**To:** Interested Parties  
**From:** City of Beaverton Planning Division  
**Date:** March 9, 2023  
**Subject:** DR2022-0098 / PD2022-0003 / SDM2022-0004 Organic Milk Exchange

## STAFF REPORT

**Application/project name:** Organic Milk Exchange

**Application Numbers:** DR2022-0098 / PD2022-0003 / SDM2022-0004

**C5.8**

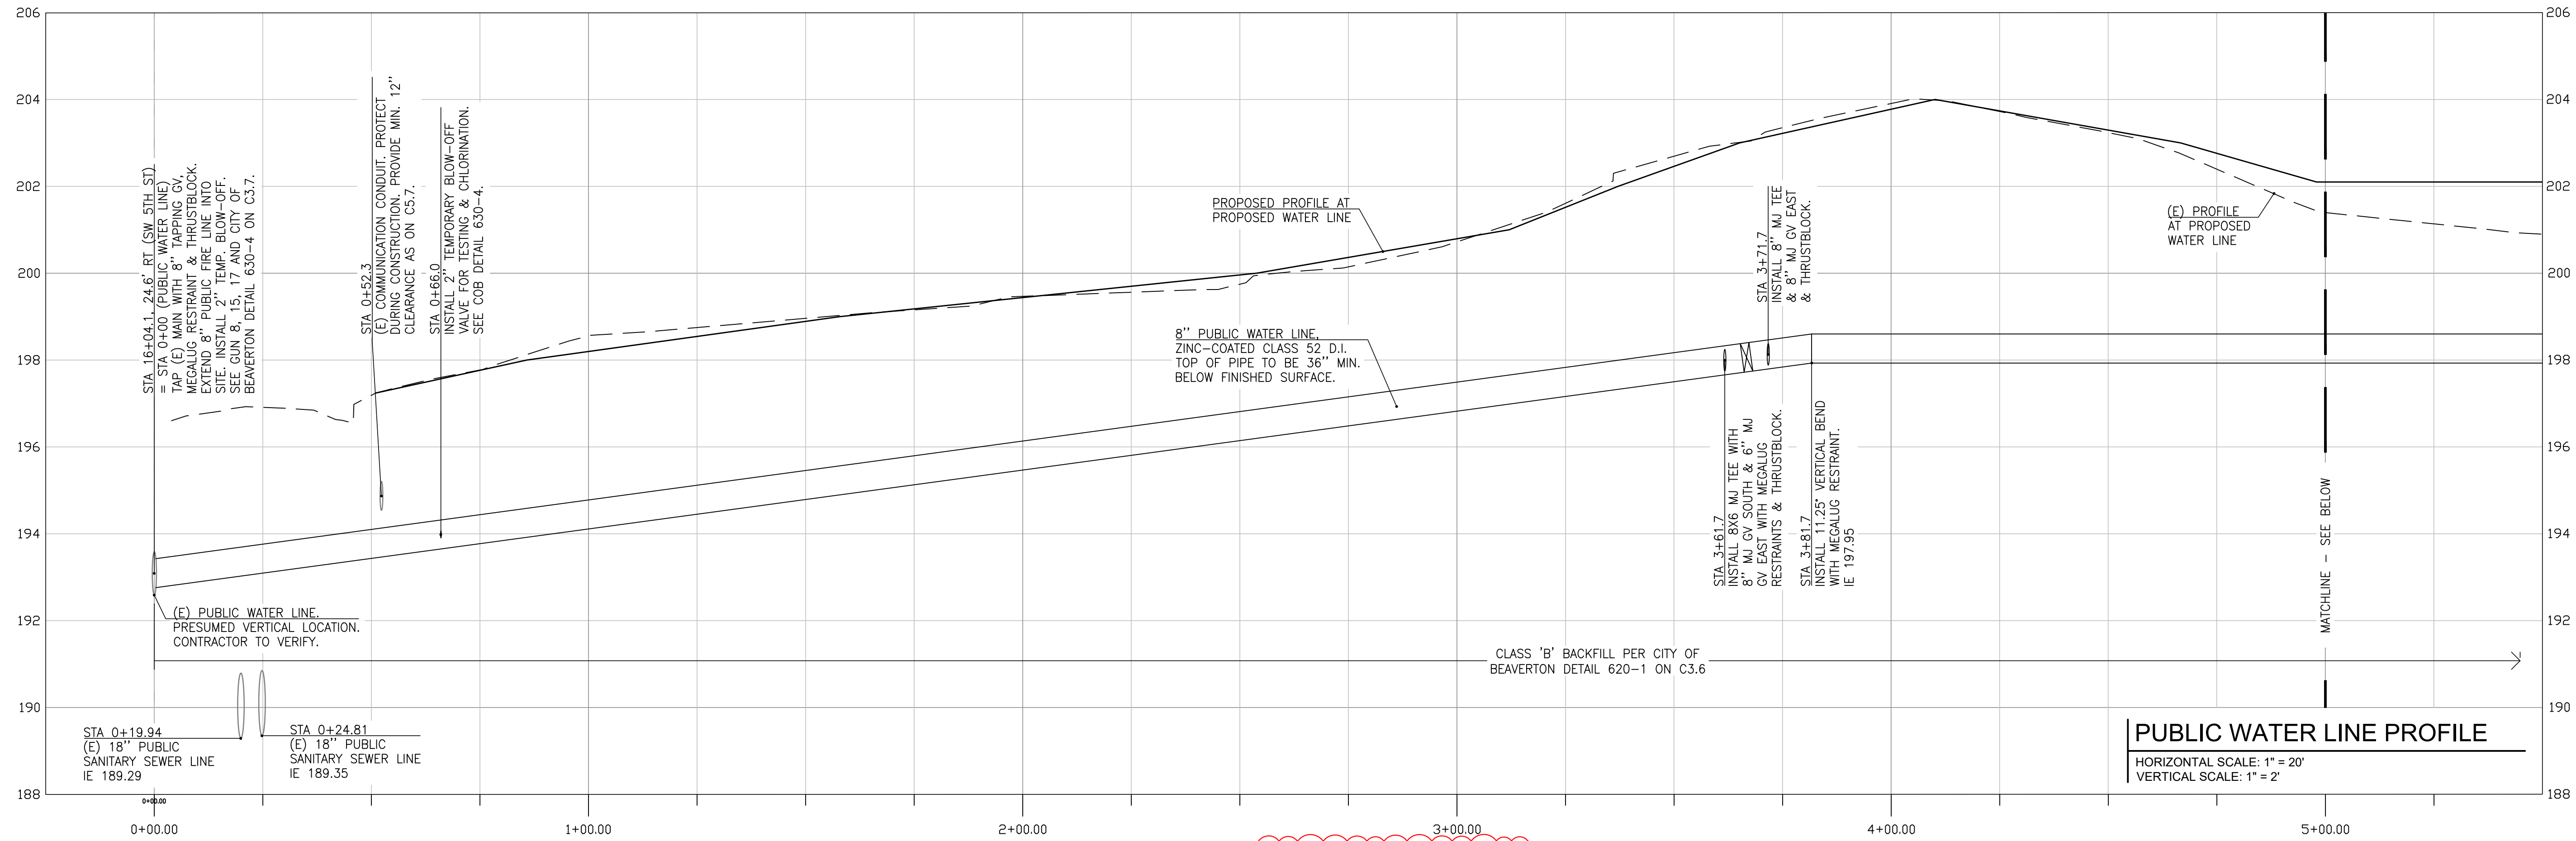
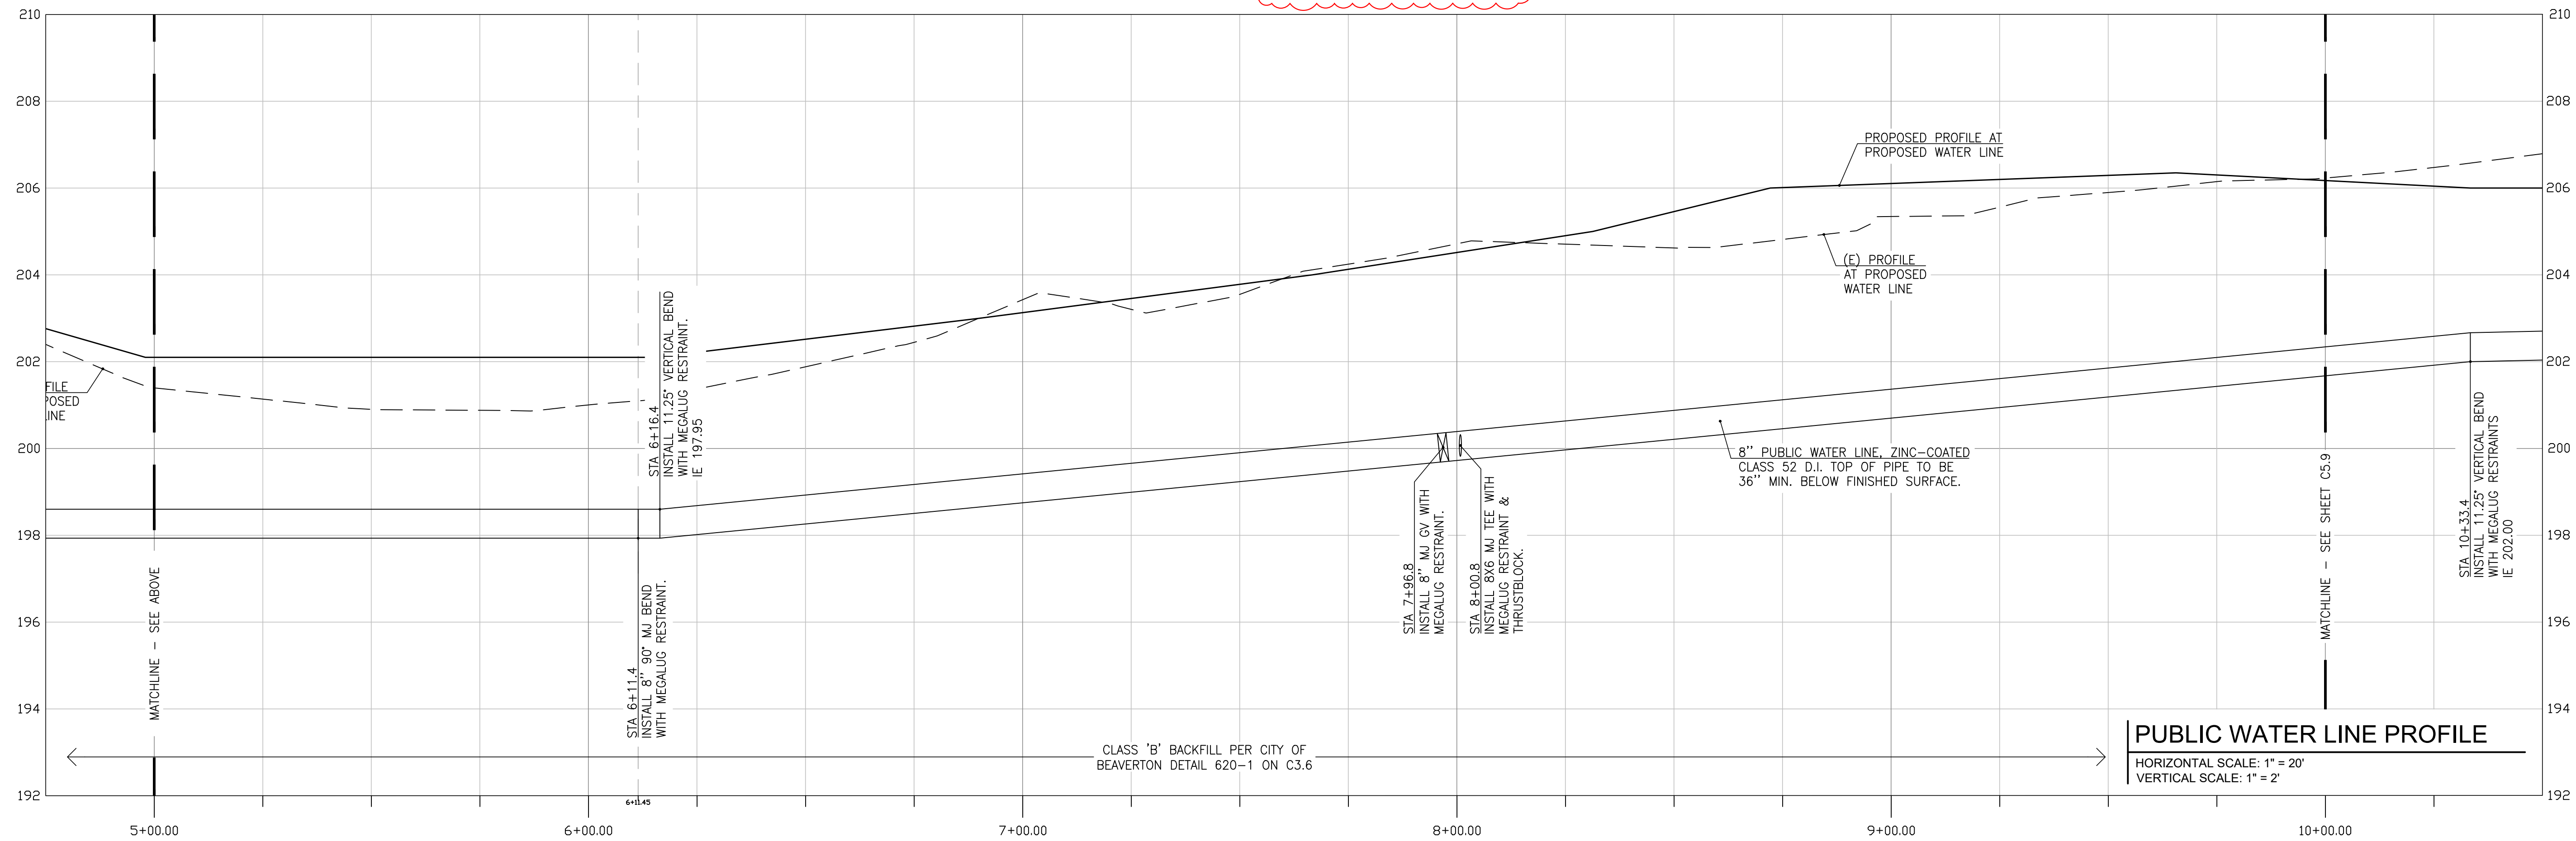
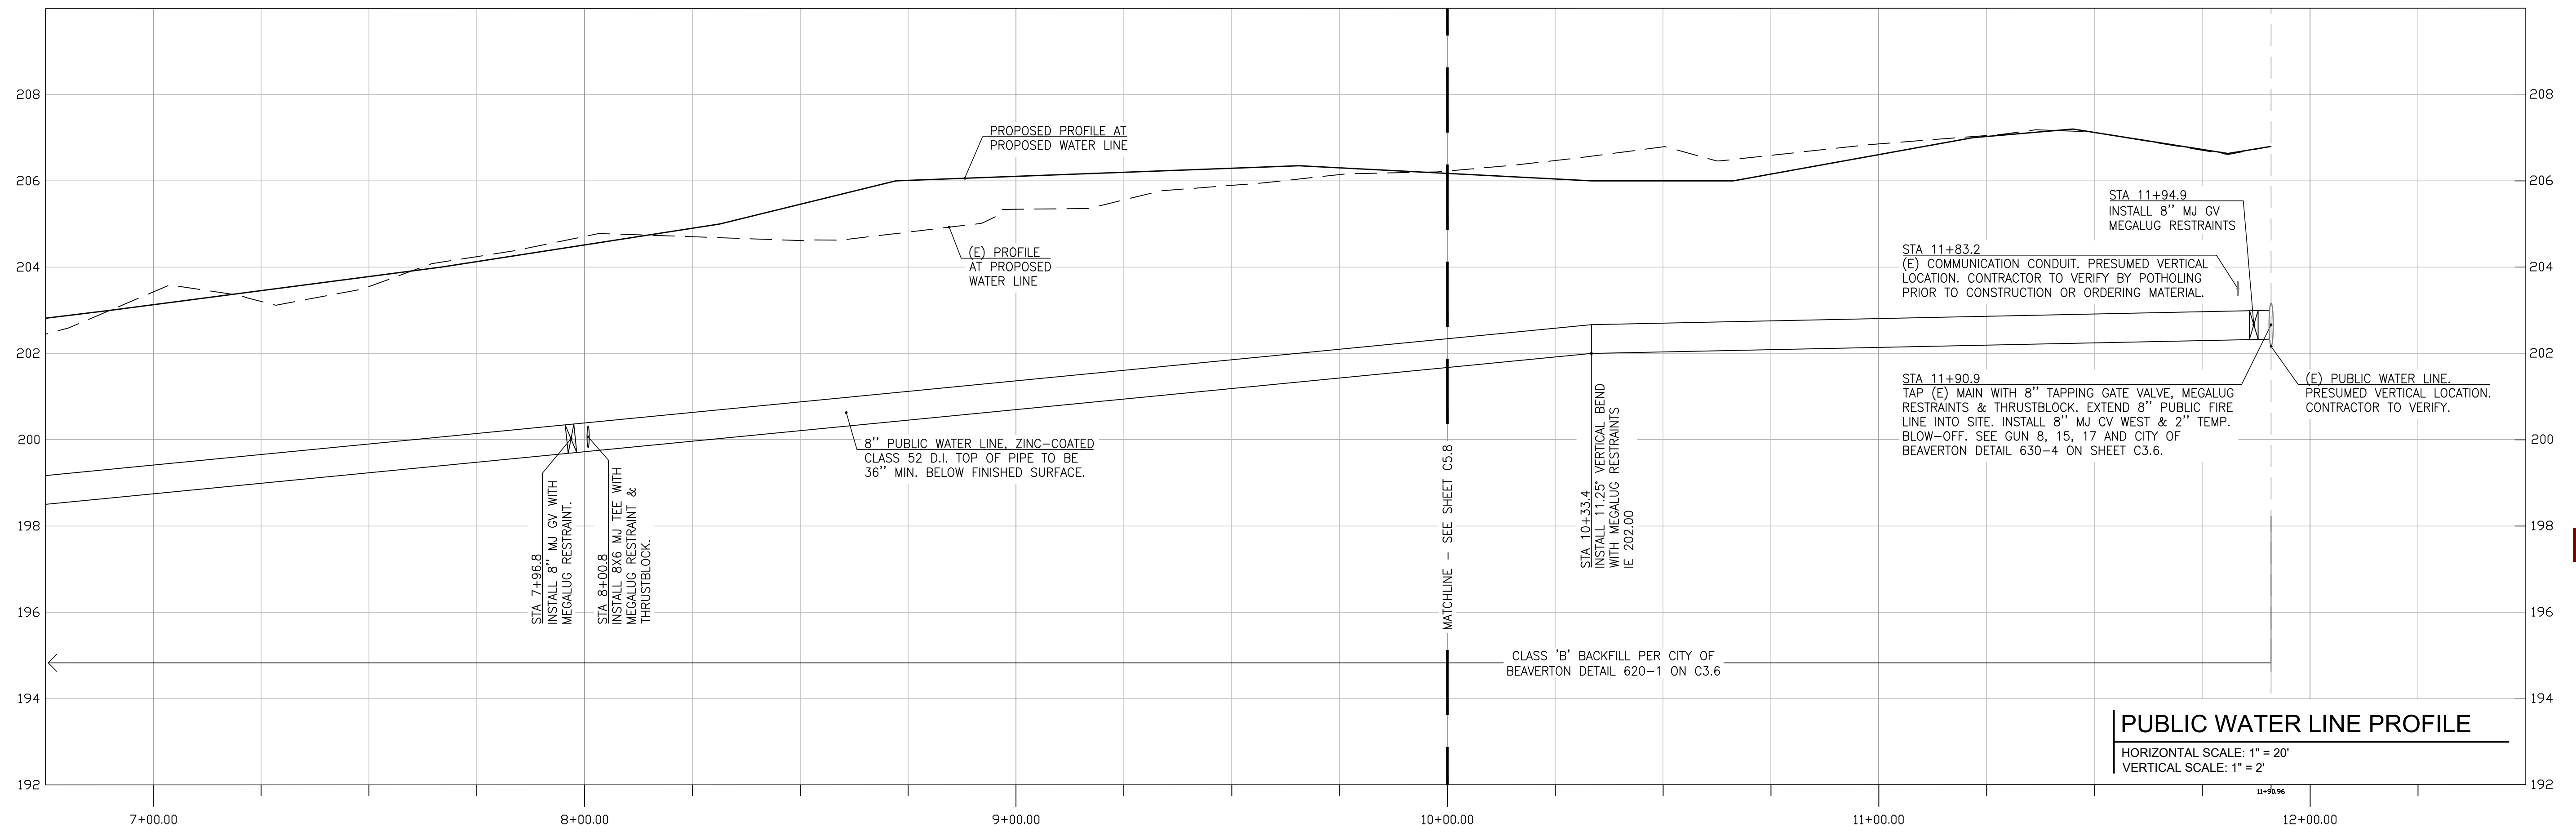
2. Show a minimum 12" vertical clearance for public water line from communication conduit at station 11+83.2. Current separation shown on sheet C5.9 is only 4".

8. Provide public water line profile.
- **Response:** *The engineer has requested that they submit the entire engineering plan set which includes all the public water line work. See C5.8 and C5.9.*
